Office Action Summary	Application No. 10/586,871	Applicant(s) MERZ ET AL.	
	Examiner KEITH COLEMAN	Art Unit 3747

DETAILED ACTION

Claims 9-28 are rejected under 35 U.S.C. 102(b) as being anticipated by Kovacs et al. (US Patent No. 4,008,009).

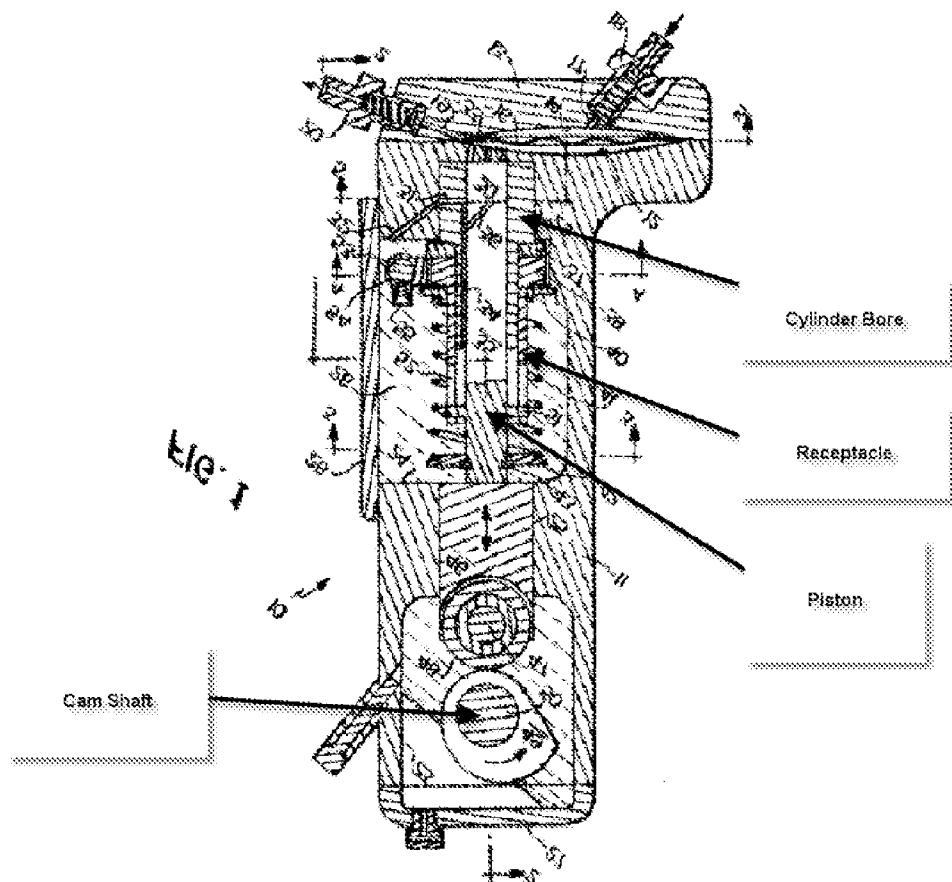
The patent to Kovacs et al. clearly shows Applicant's claimed subject matter in Figure 1.

Fig. 2

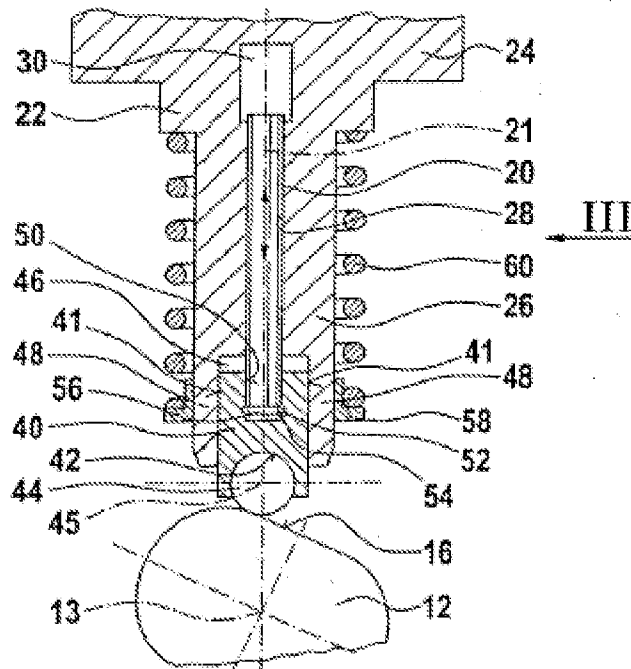
Applicant has amended the claim language to overcome the previous cited reference by adding the limitation of “wherein an end of the cylinder bore oriented toward the drive shaft terminates at a plane containing a wall of the receptacle”
